## Final Product/Process Change Notification

Document #:FPCN24698X

<b>Title of Change:</b>	Lead Frame Vendor and Design change for QFN15 Products Assembled in UTAC (UTL) , Bangkok, Thailand.	
<b>Proposed First Ship date:</b>	08 Nov 2022 or earlier if approved by customer	
<b>Contact Information:</b>	Contact your local onsemi Sales Office or <a href="mailto:Marty.Paul@onsemi.com">Marty.Paul@onsemi.com</a>	
<b>PCN Samples Contact:</b>	Contact your local onsemi Sales Office. Sample requests are to be submitted no later than 30 days from the date of first notification, Initial PCN or Final PCN, for this change. Samples delivery timing will be subject to request date, sample quantity and special customer packing/label requirements.	
<b>Additional Reliability Data:</b>	Contact your local onsemi Sales Office or <a href="mailto:Shiela.Crosby@onsemi.com">Shiela.Crosby@onsemi.com</a>	
<b>Type of Notification:</b>	This is a Final Product/Process Change Notification (FPCN) sent to customers. FPCNs are issued 90 days prior to implementation of the change. onsemi will consider this change accepted, unless an inquiry is made in writing within 30 days of delivery of this notice. To do so, contac

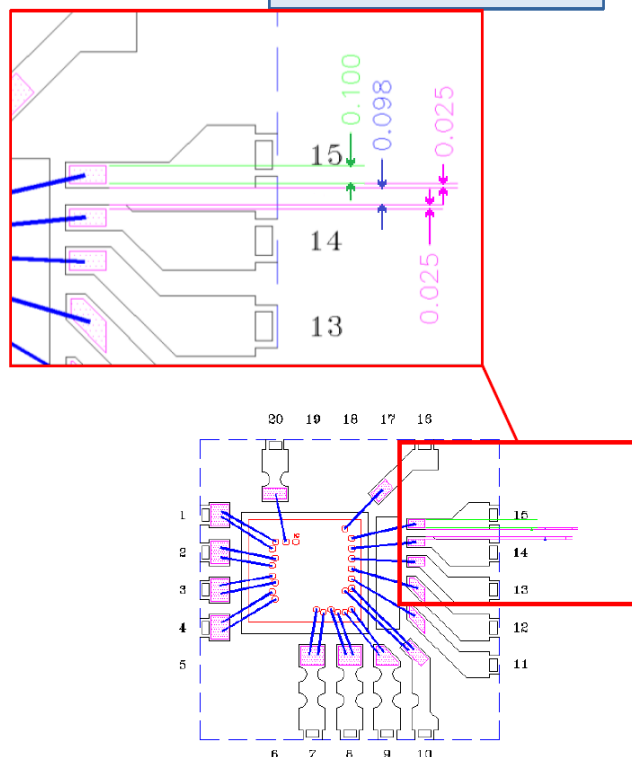
<b>Marking of Parts/ Traceability of Change:</b>	Affected products will be identified with date code. Products may contain either leadframe vendor after the 90day expiration of this FPCN. Contact onsemi for the exact date code.	
<b>Change Category:</b>	Assembly Change	
<b>Change Sub-Category(s):</b>	Material Change	
<b>Sites Affected:</b>		
<b>onsemi Sites</b>	<b>External Foundry/Subcon Sites</b>	
None	UTAC, Thailand	
<b>Description and Purpose:</b>		
This is an FPCN to notify customers that onsemi has completed qualification of a new vendor for the leadframe in the QFN-15 package assembled at the UTAC, Bangkok Thailand location for the products listed in this announcement. The previous vendor has discontinued their leadframe product. As a result, the following changes will occur:		
	<b>Before Change Description</b>	<b>After Change Description</b>
LeadFrame	Lead frame vendor CWTC with 0.30-1.2 microinch bottom plating	Lead frame vendor Rokko with 1.38 microinch bottom plating and below dimension changes.

Current design CWTC supplier

Rokko supplier
